Subject: AP1000 Response to Request for Additional Information (SRP 7)

RAI-SRP7.1-ICE-03 R1
RAI-SRP7.9-ICE-11 R1

AP1000 TECHNICAL REPORT REVIEW

RAI Response Number: RAI-SRP7.1-ICE-03

RAI-SRP-7.1-ICE-03 Attachment

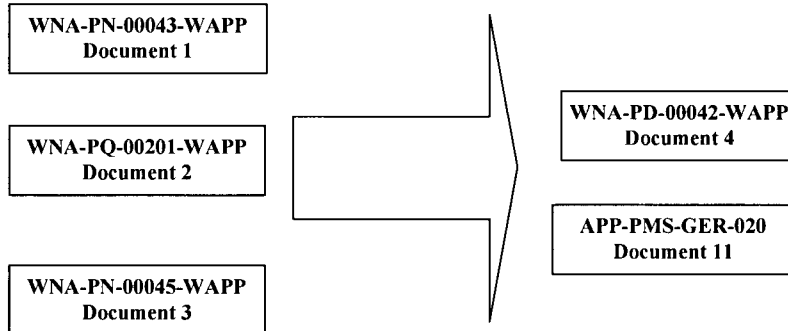
Provide a roadmap describing the relationship between the eleven documents that comprise Design Requirements Phase.

Westinghouse provided eleven documents that comprise the design requirements phase of the AP1000 software development lifecycle. On April 9-11, 2008, the NRC staff conducted a site visit to Westinghouse's Rockville, MD office to review the eleven documents. However, the staff had difficulty navigating through the eleven documents as there were multiple references in a single document to one of the other eleven documents, or references to documents that were not present at the office. Therefore, a roadmap is needed that shows the peer-to-peer relationship, as well as, what documents serve as subordinates to others and what documents serve as supervisory documents to others.

The attached figure shows the relationship of the eleven planning documents. Since the October 2006 meeting, the AP1000 planning documents (Documents 1-4 and 11) have been revised and their document numbers have changed as follows:

Westinghouse has revised the original figure attached to the RAI response to more accurately reflect the relationship of the eleven documents with one another.

Figure 1
Relationship Between PMS Software Development Plan and the AP1000 Cyber Security Plan and its References

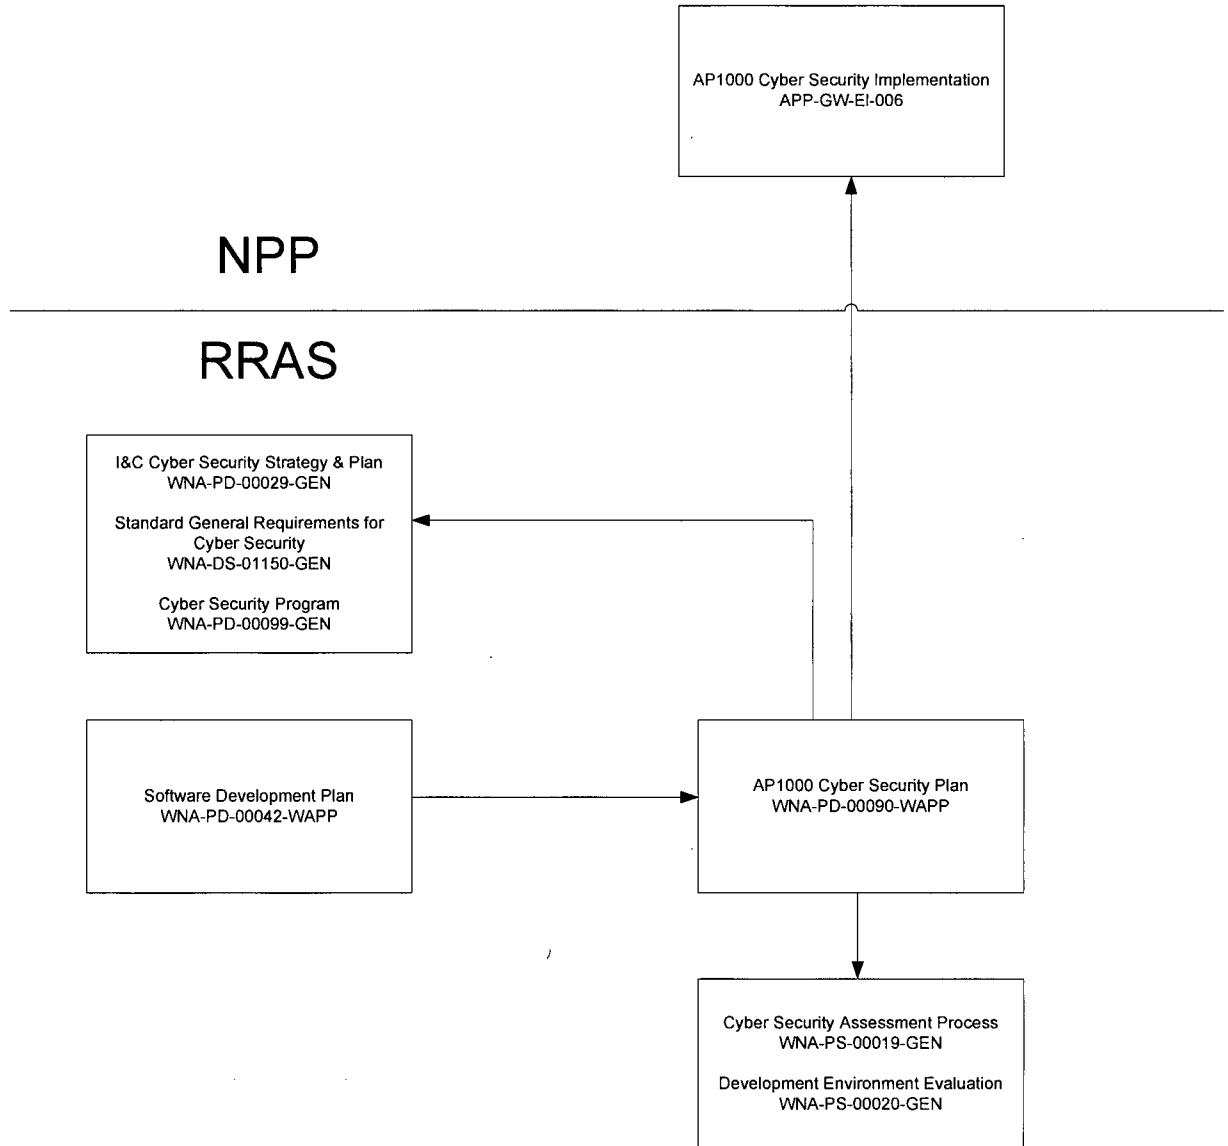
Provide additional information on the implementation of cyber security measures for the non-safety data network. Demonstrate how the network design prevents unauthorized access of the non-safety network.

In Section 3.1.3 of WCAP-16774-P, Westinghouse commits to providing off-site access security via the use of multilayered firewalls, with the Ovation System providing only unidirectional access to higher and higher levels in the hierarchy. Demonstrate via text and schematics how this hierarchy is defined. For example, where are the firewalls placed? What types of firewalls will be used (e.g. stateful, stateless)? How will Westinghouse prevent workstations within higher security levels from downloading malicious code (either intentionally or unintentionally) from devices at lower security levels?

At the January 29-30 meeting, the NRC stated that there was inadequate information regarding the cyber security assessments in WNA-PD-00042-WAPP, Rev. 1, "NuStart/DOE Design Finalization Protection and Safety Monitoring System Software Development Plan." The description should include the systems that will be assessed and the criteria used to assess the systems.

Westinghouse has developed an AP1000 Cyber Security Plan (WNA-PD-00090-WAPP) that will be provided to the NRC for audit. It will describe the cyber security program for AP1000 and reference the cyber security criteria, program description, and procedures that will be employed. The AP1000 PMS Software Development Plan (WNA-PD-00042-WAPP) will be revised to reference this AP1000 Cyber Security Plan. The attached figure illustrates the relationship of the AP1000 PMS Software Development Plan, the AP1000 Cyber Security Plan, and the criteria, program description and procedures that will be employed.
